South Texas Project Electric Generating Station 4000 Avenue F – Suite A Bay City, Texas 77414

February 10, 2010
U7-C-STP-NRC-100036

South Texas Project
Units 3 and 4
Docket Nos. 52-012 and 52-013
Response to Request for Additional Information

Attached are the responses to the NRC staff questions included in Request for Additional Information (RAI) letter numbers 299 and 302 related to Combined License Application (COLA) Part 2, Tier 2, Sections 3.7.1, 3.7.2 and 3.8.4.

Figure 3H.6-138 Broadened Horizontal FRS for RSW Piping Tunnels

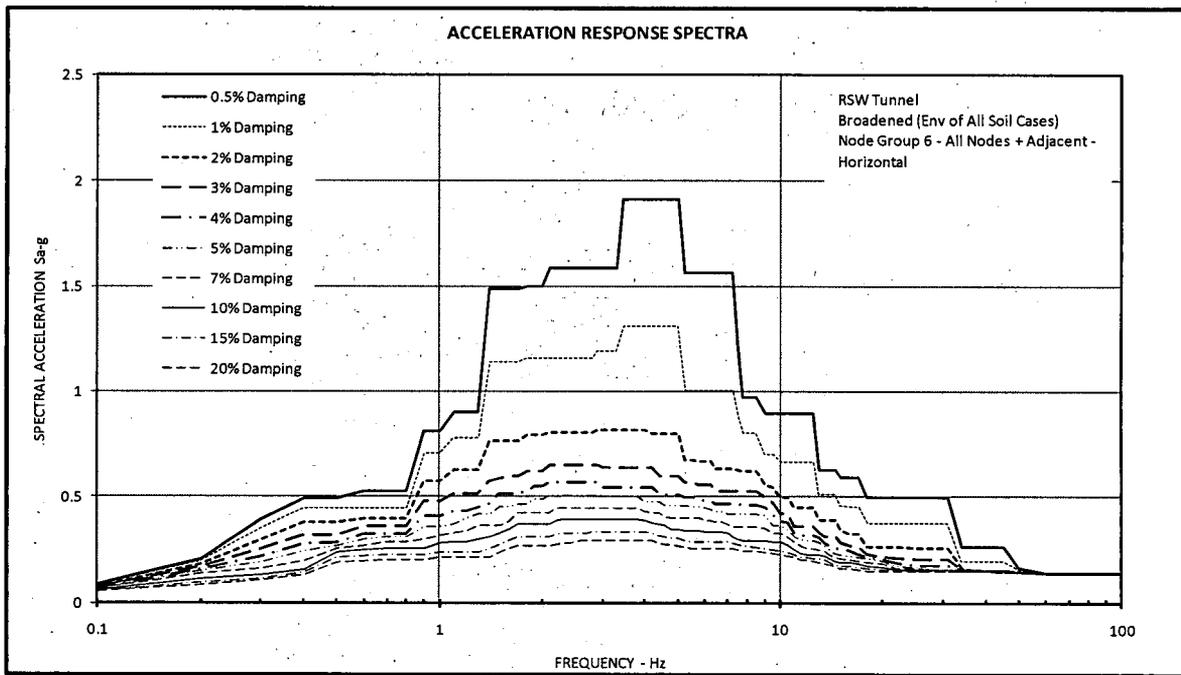
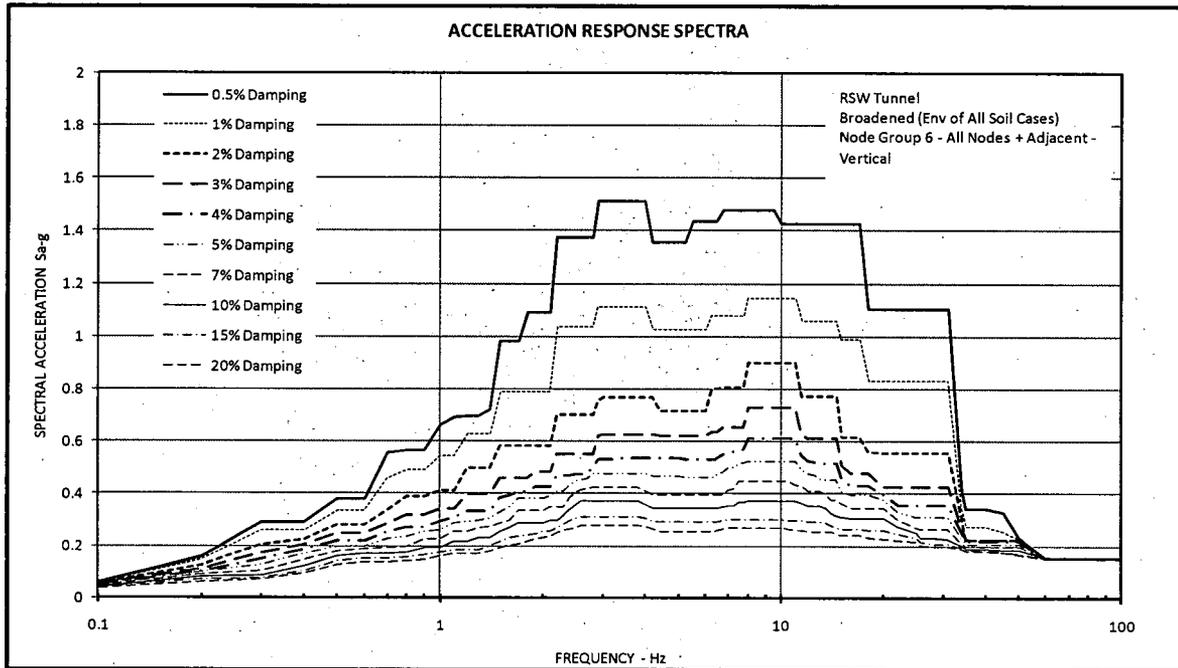
1. A description of the equivalent static analysis method used for the RSW piping tunnel.
2. A description of how the seismic and static loads were calculated and applied to the model. Show the model and boundary conditions including the soil springs used in the analysis.
3. A description of the type of strains (tensile or compression) were calculated in the RSW piping tunnel.
4. A description of how both axial strain and transverse shear demands were considered in the analysis of the RSW piping tunnel.
5. A description of how the concrete elements of the RSW piping tunnel were determined to be rigid so that there are no in-structure amplifications.
6. Describe the SSI analysis from which the accelerations are obtained to establish the SSI forces for the analysis of the RSW piping tunnel (see the last bullet in Section 3H.6.6.2.2).

In order to quantify the in-structure amplification and ensure that the use of 0.21g ZPA adequately accounted for in-structure amplification, a two-dimensional SSI analysis of the RSW tunnel is performed. Attached Figures 3H.6-138 and 3H.6-139 show the resulting amplified response spectra for all the walls and slabs of the tunnels. As can be seen from these figures, the amplified ZPA of these response spectra are less than 0.21g ZPA acceleration used for the design of tunnels' walls and slabs.

Figure 3H.6-40: SAP Finite Element Model for UHS and RSW Pump House Design

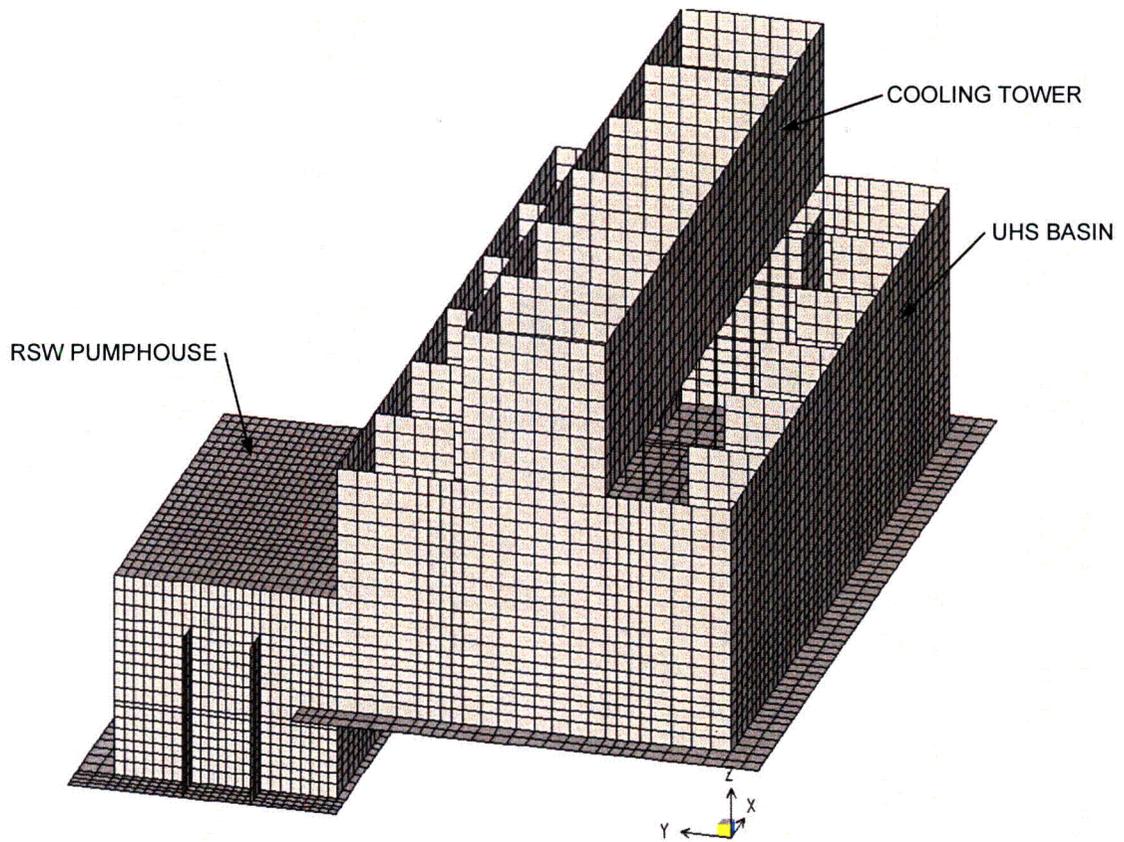
1. In the response to Item 2 of RAI 03.07.01-4, the finite element model of the UHS basin and RSW Pump House was not provided in Figure 3H.6-40 (this figure was supposed to be part of the response to RAI 03.07.01-13). The applicant is requested to ensure this information be part of Figure 3H.6-40, including a plot showing the basement slab and soil-retaining wall mesh configuration and grid sizes. The response to Item 2 of RAI 03.07.01-4 also states that, *“The model mesh size is detailed enough to model the principal features of the structure and transmit a frequency of at least 33 Hz.”* The applicant is requested to a) provide the criteria and quantitative basis to show that the element sizes are sufficiently small to transmit frequencies of up to 33 Hz for the three soil cases; and b) provide a justification that the aspect ratio of the elements is sufficiently small as not to affect the solution accuracy.

1. Figure 3H.6-40 has been provided as part of the Supplement 1 response to RAI 03.07.01-13 (see letter U7-C-STP-NRC-090208 dated 11/19/2009) and for convenience is reproduced below. Note that this figure provides the Finite Element Model (FEM) used for design of the ultimate head sink (UHS) and reactor service water (RSW) pump house. In this FEM, the basemat is represented by shell elements, whereas in the FEM model for the soil-structure interaction (SSI) analysis (see Figure 3H.6-15a) the basemat is represented by solid elements. Solid elements are required for proper modeling of interaction between the soil and the structure in the SSI analysis.
